**ADDENDUM 04**

**FORMER TERRITORIAL  
COURTHOUSE NHSC**

**TYP SECTION DETAILS**

**A2.620**

**4 SECTION DETAIL - ROOF CAP @ NORTH - NEW CONSTRUCTION**  
A2.224 1:5

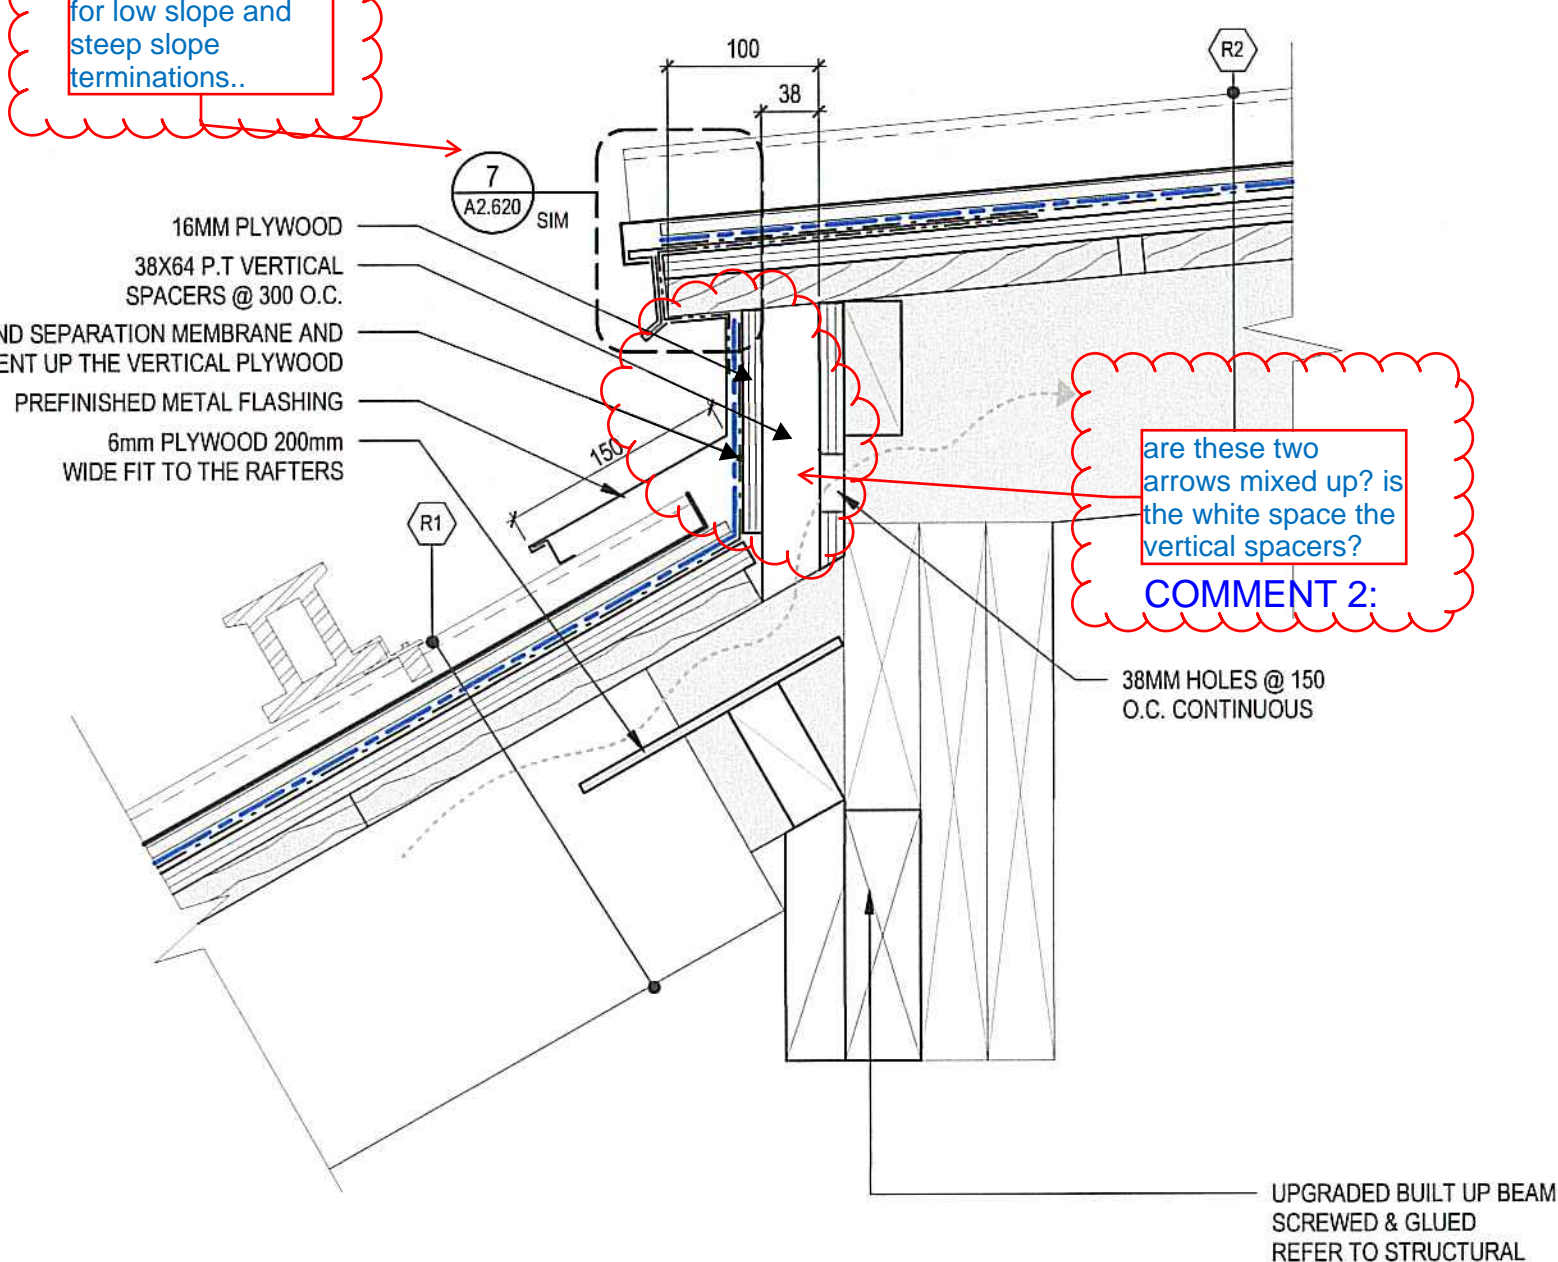
**COMMENT 1:**  
Is this an incorrect reference? details are not the same for low slope and steep slope terminations..

**6 SECTION DETAIL - TYP ROOF CAP WITH NEW VENT**  
A2.224 1:5

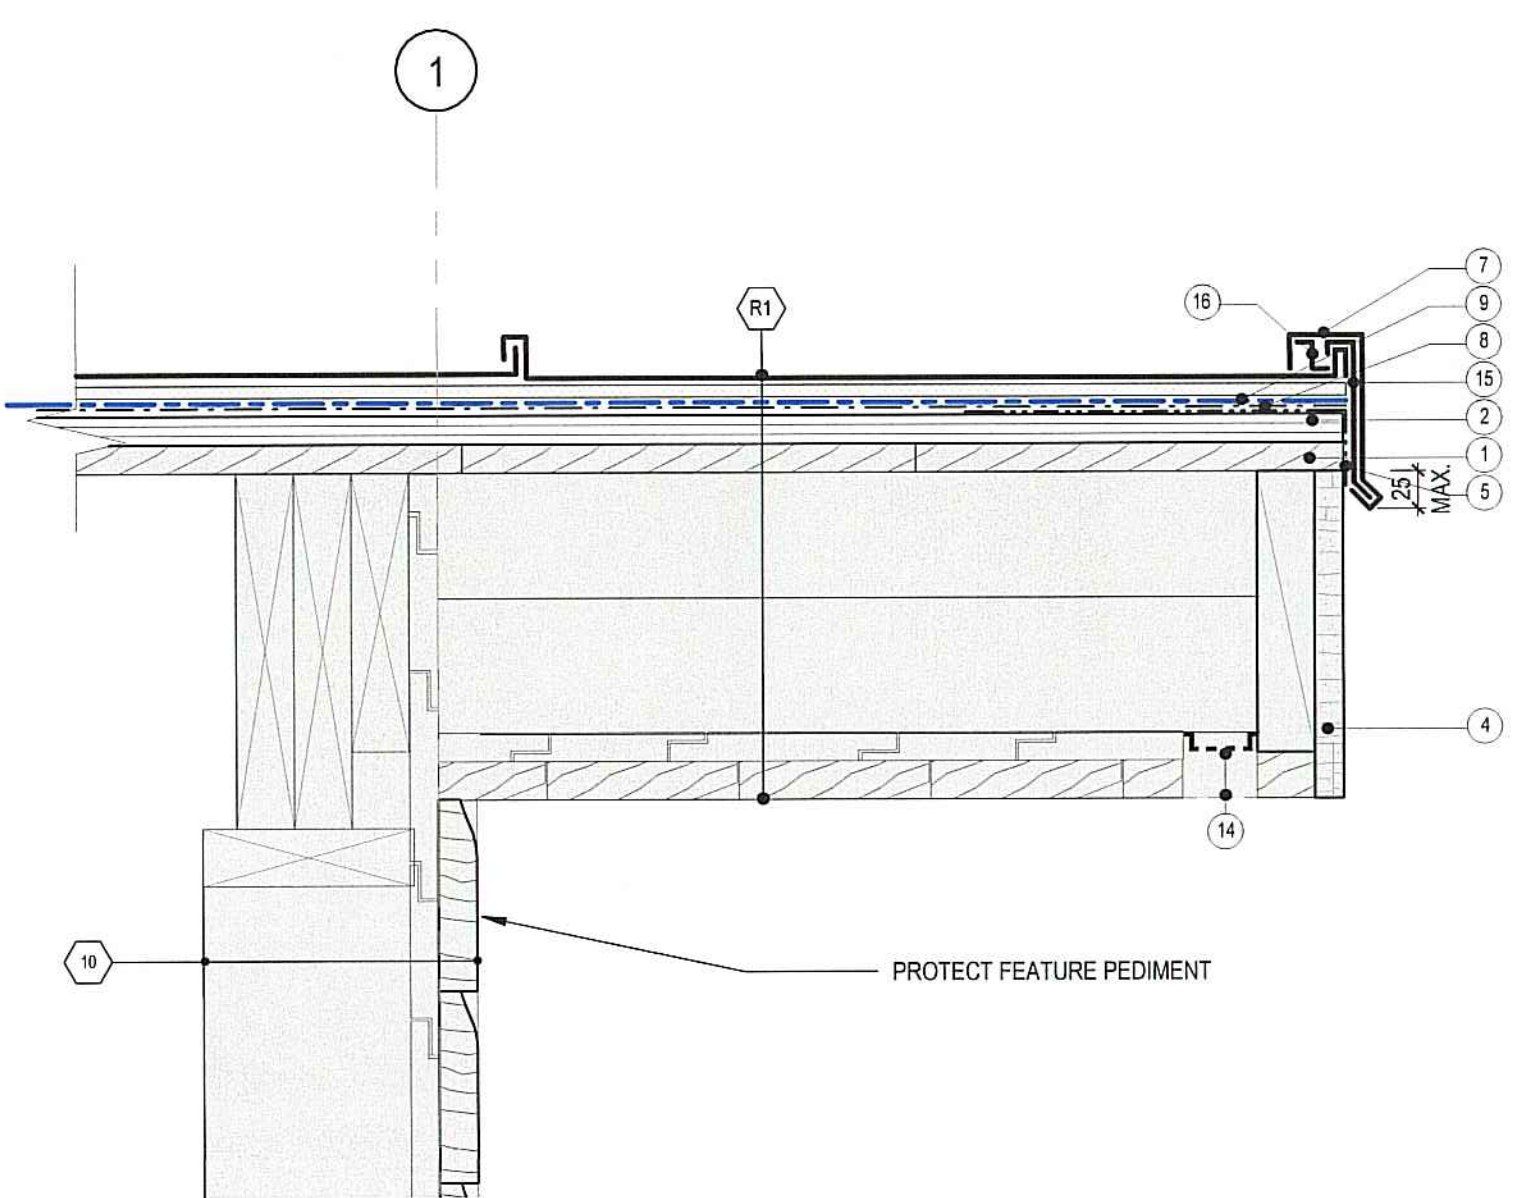
**COMMENT 2:**  
are these two arrows mixed up? is the white space the vertical spacers?
